_ FCO RF72-0001-DAS, Command Timeouts

| DIGITAI | FCO FCO | | | | | | EGOR 0] | Y | PAGE OF | 1 10 | |
|-------------------------------|---|-----------------|-------------|--------------------------------------|-----------|-------------------|--------------------------------------|--------------|------------------|---------|------|
| FIELD CHANGE ORDER | | | | | | 1 | NUMBER: | RF7 | 2-0001 | | |

| MICROMEDIA | Microfiche Libraries, | FCO REVISION |
|-----------------|-----------------------------|--------------------|
| | FC | CO RF72-0001 |

Figure 1 Before Module Removed

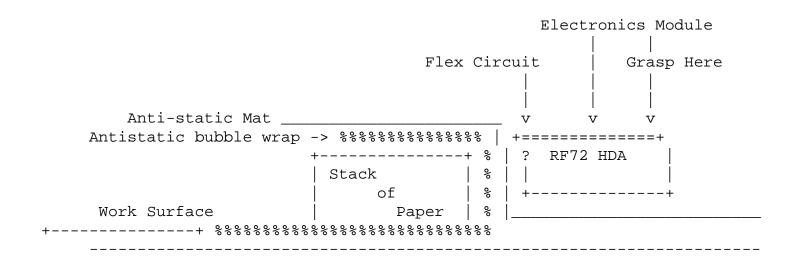
- 3. Perform an orderly system shutdown, using the appropriate system shutdown procedures.
- 4. Power down the entire system and expander boxes if applicable.
- 5. Setup an anti-static work surface as shown in Figure 1. Note the stack of paper (manuals, etc.), that is used to support the module once it is removed from the Mechanic Set (HDA).
- 6. Remove the RF72 from the storage enclosure, or mounting hardware as required, consult the appropriate manuals for this procedure.
- 7. Place the RF72 to be upgraded on the Anti-static work surface with the HDA down and the module facing up. Locate the 4 screws securing the module to the HDA.

Figure 2 After Module Removal

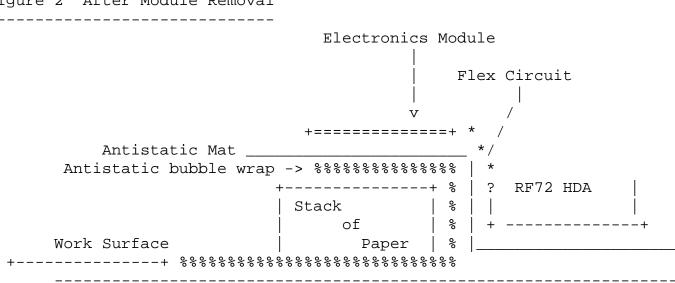
8. Remove the 4 $(4-40 \ge 1/2")$ screws, the module can now be removed from the HDA using the "Flex" connection as a hinge. (See Figure 2)
